**Development Application No. DA2025/0143**  
**Issues response/ Supplementary Statement of Environmental Effects**  
**Proposed shop top housing**  
**1749 & 1753 Pittwater Road, Mona Vale**

Reference is made to Council's request for further information (RFI) of 30<sup>th</sup> May 2025 and a number of subsequent meetings and discussions with Councils relevant experts to discuss the proposed responses to the issues raised. This submission details the considered response to the issues raised and is to be read in conjunction with the following amended/additional plans and documentation:

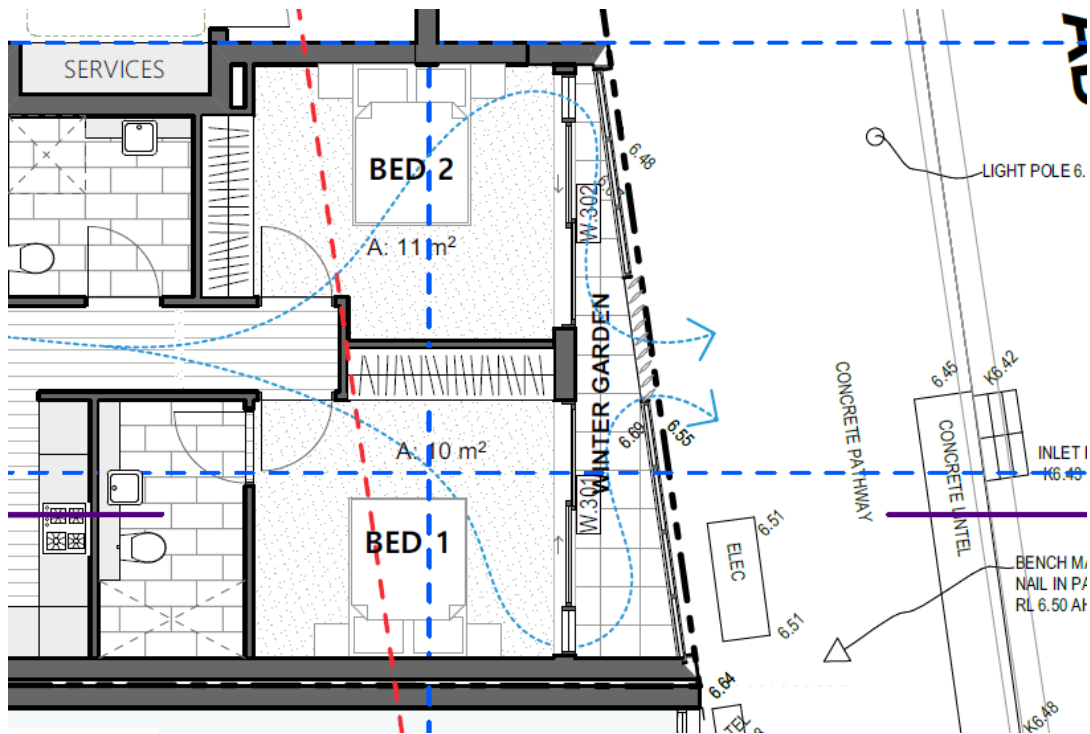
Response: In response to this concern the Pittwater Road facing operable fenestration and its relationship to the operable component of the winter gardens ensures that there is sufficient to offset/ battling between operable window glazing contained within the primary building façade and the operable component of winter gardens to provide appropriate acoustic attenuation to traffic noise whilst facilitating the maintenance of natural ventilation as depicted in the plan extract over page.
